New Monumental Arch

Memorial Avenue, Washington, DC

Approval of Final Site and Building Plans

NCPC File Number: 8778

Final Site Plan - Updated

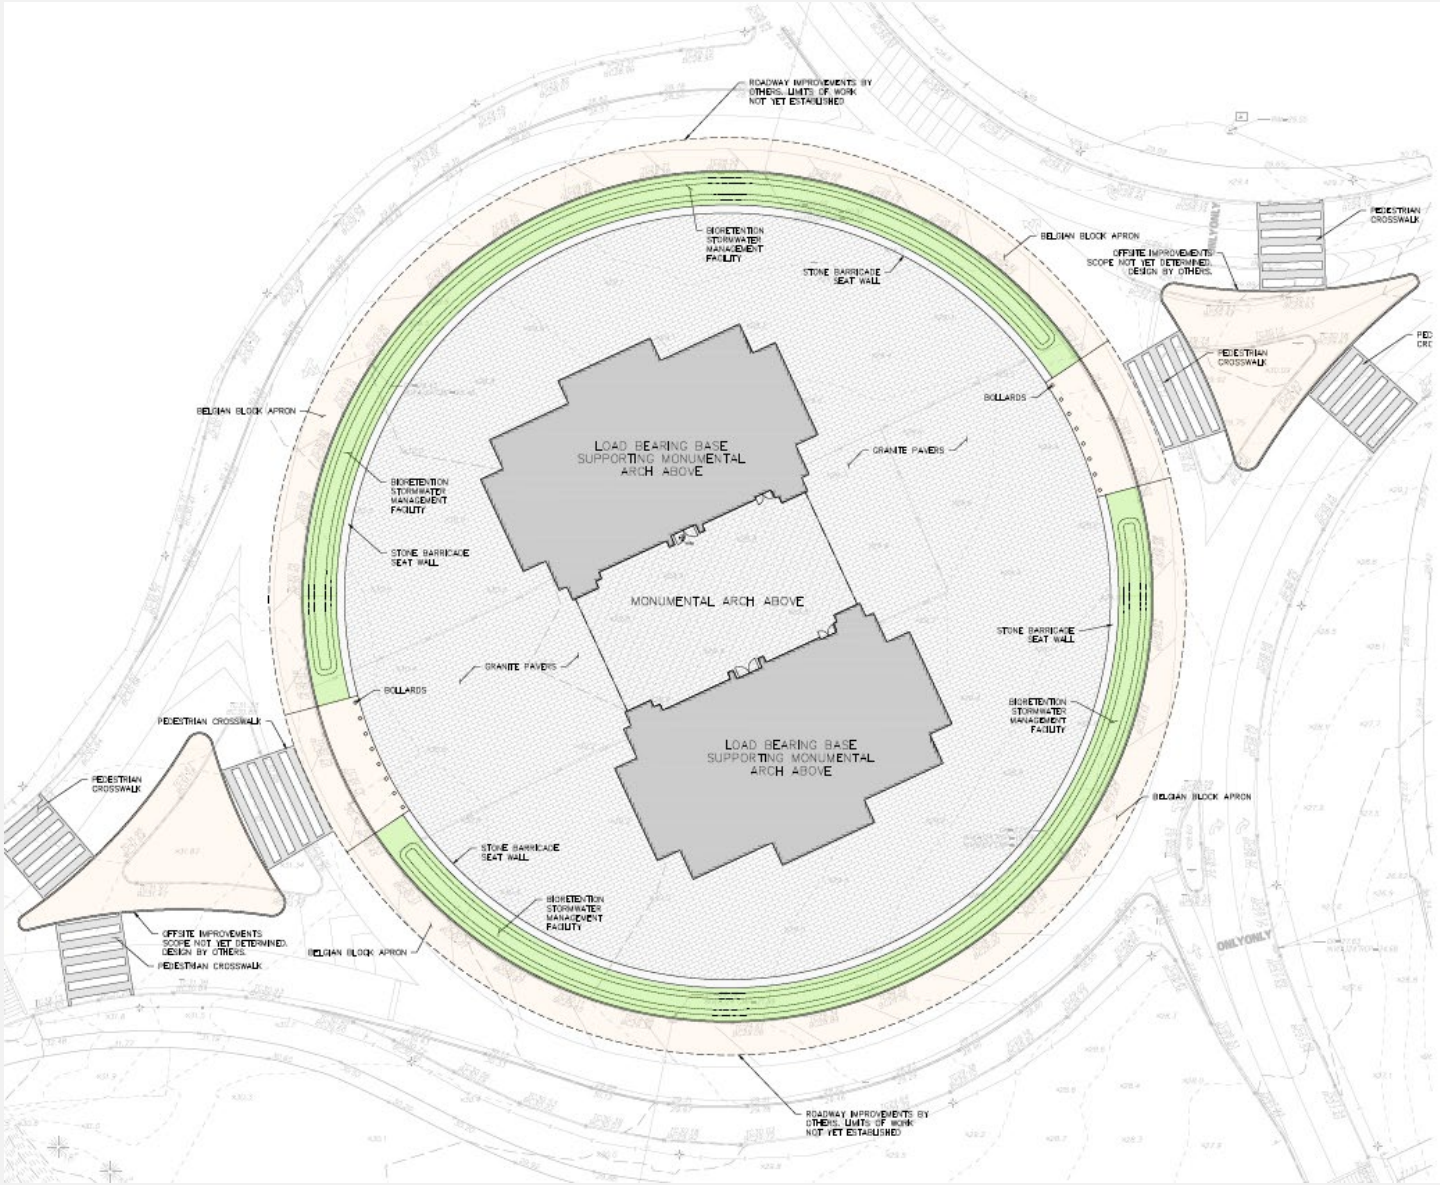
Updated 10/21/26:

- 15 Traffic Signals removed, 2 minimum maintained at each pedestrian crossing

Proposed Traffic Circulation Changes

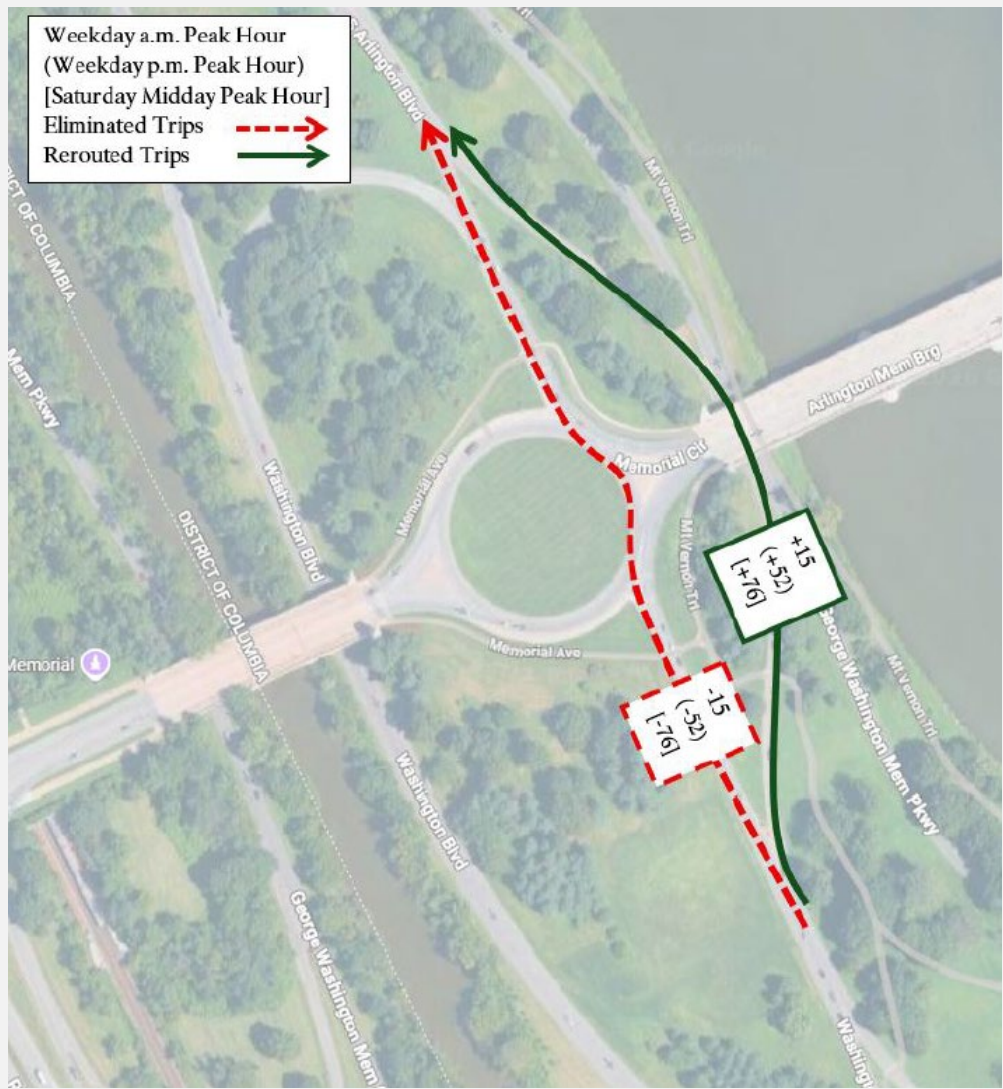
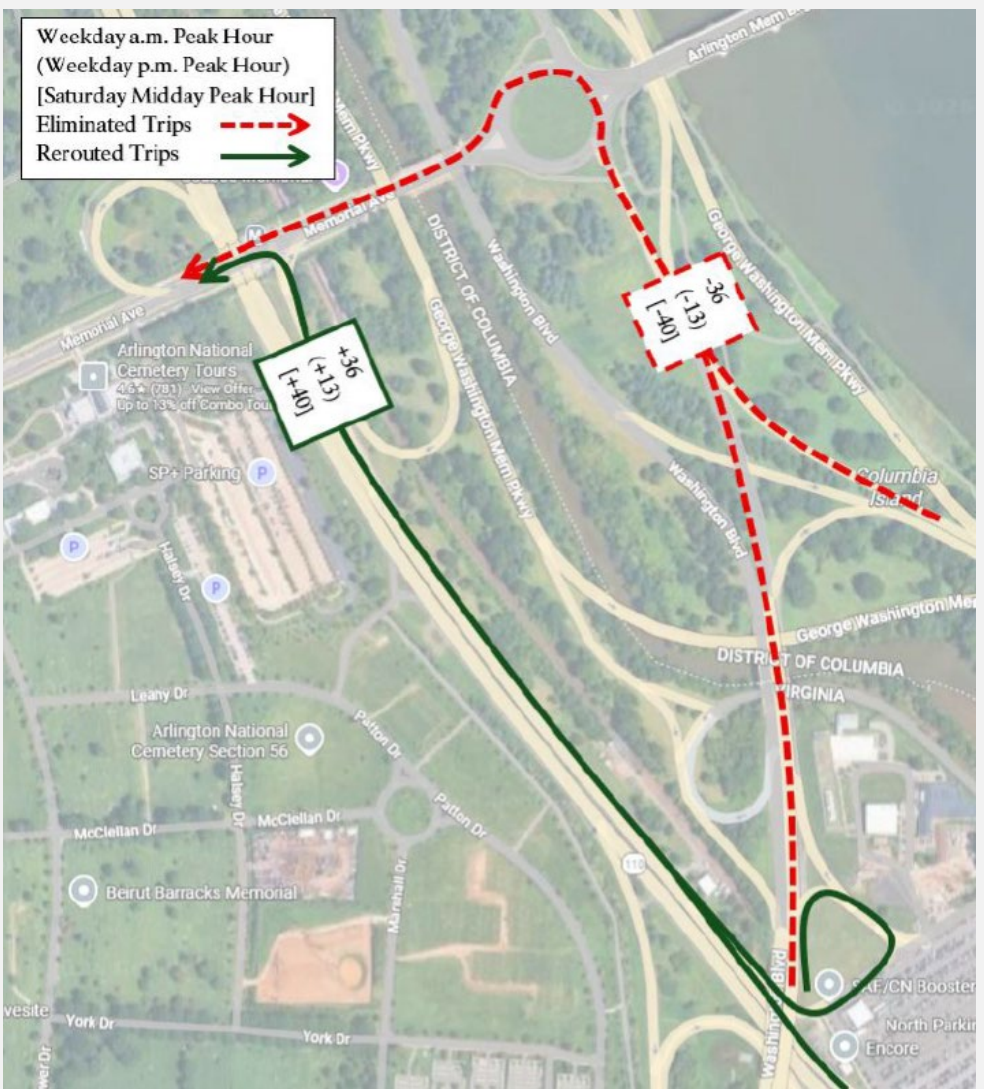
Project eliminates:

- 1. Washington Boulevard northbound through movements
- 2. Washington Boulevard northbound to westbound Memorial Avenue

Traffic will be rerouted

Traffic Signal Updates

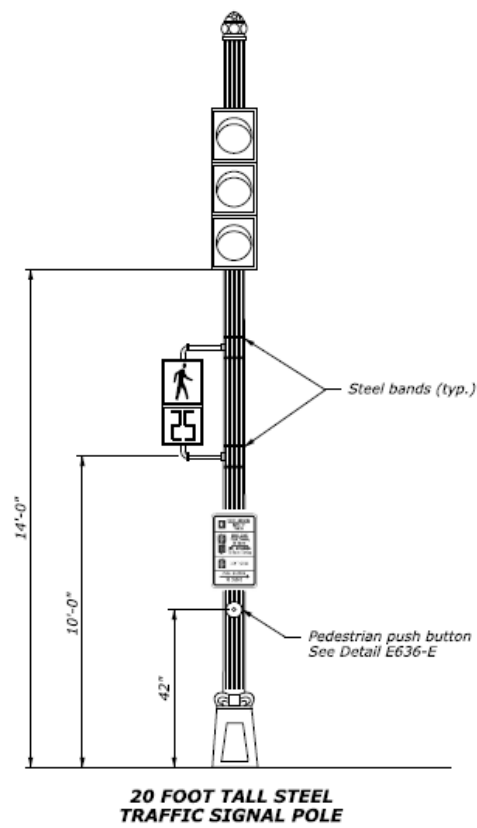
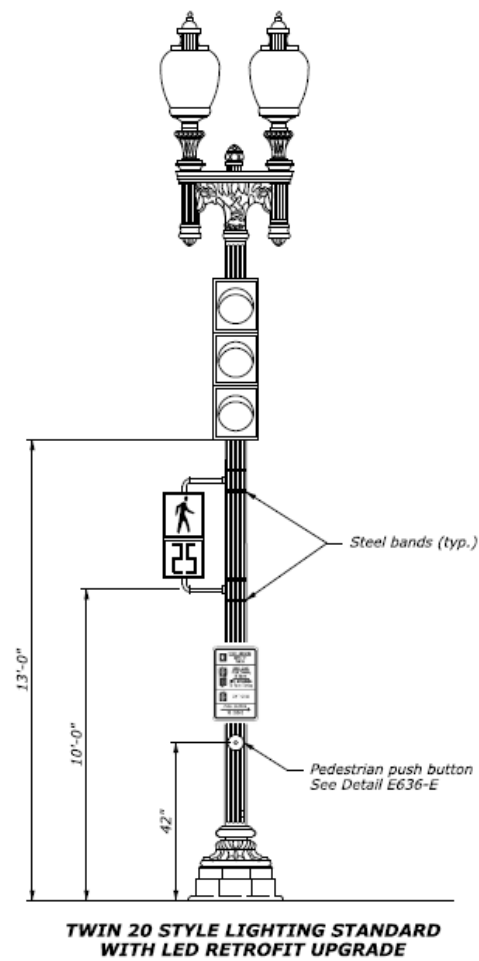
To reduce visual clutter within the landscape and provide a more representative estimate of the infrastructure required, an analysis was conducted to evaluate potential sight-distance and visibility constraints for each signal face. Based on this analysis, 15 traffic signal posts were eliminated from the preliminary design. Each signalized crosswalk will retain a minimum of two traffic signal posts and the necessary three-section vehicular signal indications, pedestrian signal indications, and accessible pedestrian push buttons.
